NATIONAL RADIO ASTRONOMY OBSERVATORY

ELECTRONICS DIVISION TECHNICAL NOTE NO. 105

TITLE: DIGITAL CONTINUUM RECEIVER HARDWARE MODIFICATIONS

DATE: January 6, 1982

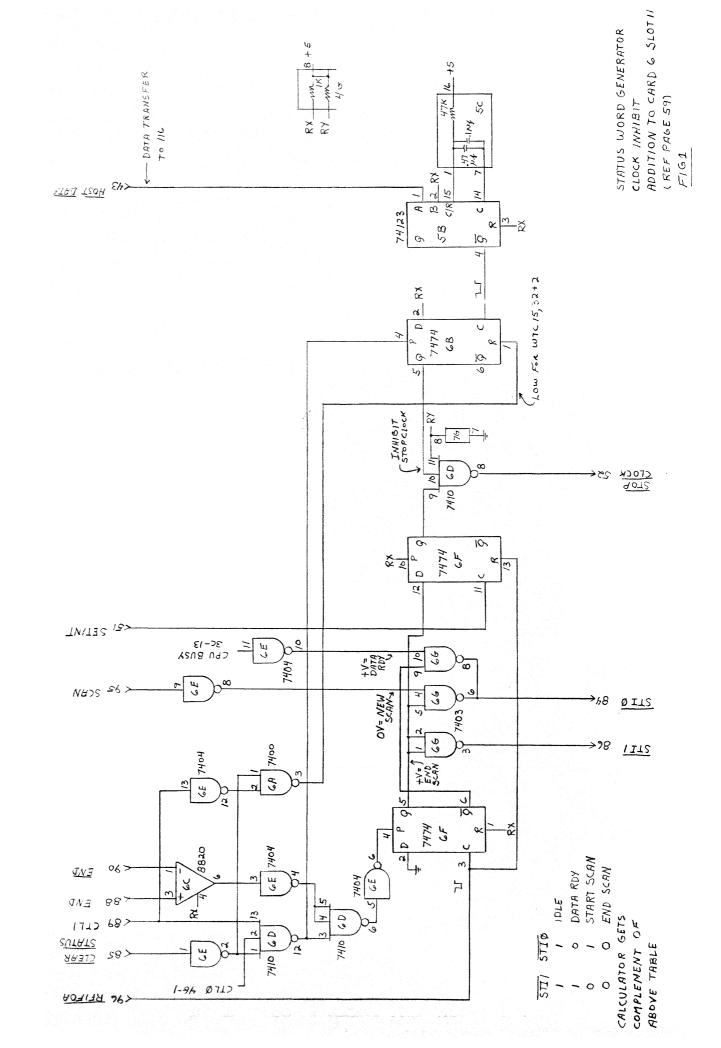
The program had to be changed so that it could determine in a reasonable amount of time when to start a new scan. This was accomplished through the addition of two status bits. (See Figure 1.) These two status bits enabled the calculator to wait for a start scan condition, after the scan has stopped. The disadvantage of this approach is that a display of receiver parameters is not displayed between scans. In order that the calculator could guarantee a stop scan condition at start up, a new command was added. This command, WTC 15, 32. forces a stop scan. When the receiver is in a stop scan condition it spends all of its time waiting for a start scan. When the scan is started, all of the time base counters (EDIR 188, page 49) are reset (Figure 2) and the calculator is now waiting on data ready or another stop scan. Being able to wait on a start scan condition reduced the time from the host computer's request to a start scan to the cycle time of the calculator.

FIG 4

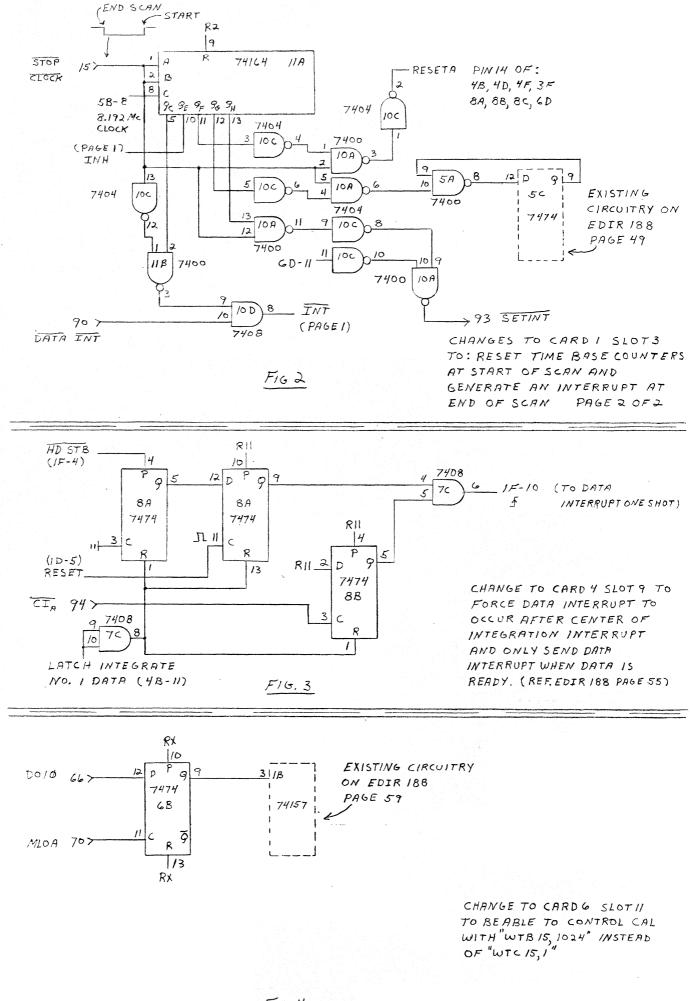
The addition of the WTC 15, 32 command caused another problem. This problem was corrected by the logic change in Figure 4. Before this cannge it was not possible to turn the cal off, due to the fact that when the control word was set to turn the cal off it also stopped the scan. The solution was to move the cal control to a write binary bit (1024) to control the cal.

ADDITION TO CARD I (SLOT 3) TO GENERATE CENTER OF INTEGRATION INTERRUPT PAGE I OF 2 (REF. PAGE 49)

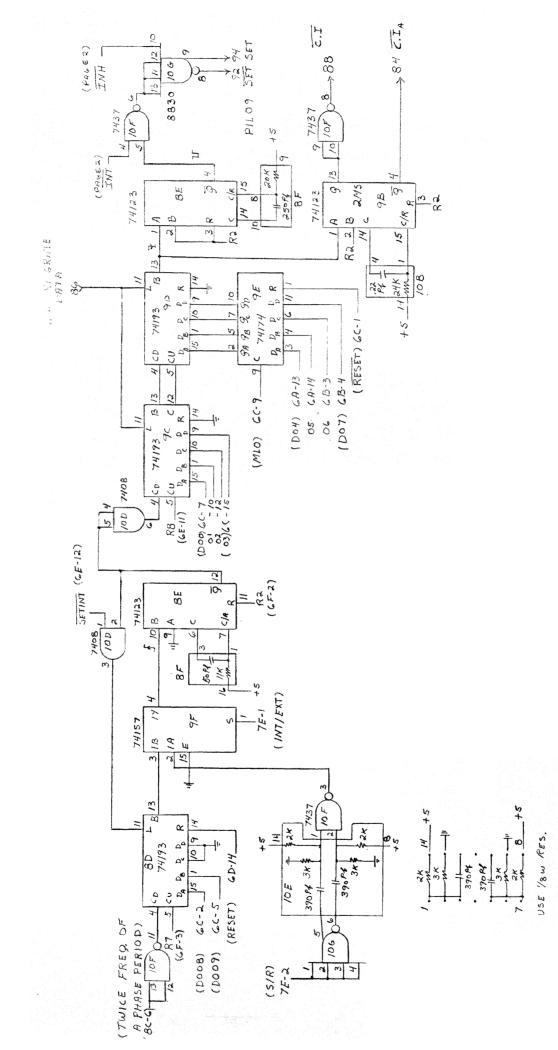
To generate a center of integration interrupt was rather an involved hardware addition. This was complicated by the fact that the host computer (300-ft DDP 116) only had one interrupt line that had to be shared as a data and center of integration interrupt. The approach used was to provide a flag $\overline{\text{CI}}$ (reference Figure 5) to tell the host computer that it was a center of integration interrupt.

The logic of Figure 5 was implemented to generate a center of integration interrupt. The basic idea of the logic was to provide a duplicate phase counter (EDIR 188, page 49) and the samples/integration counter (page 55) and run these

counters at twice the frequency as in the normal counters. When these counters count down to zero it would be half way through the integration period and would generate an interrupt.
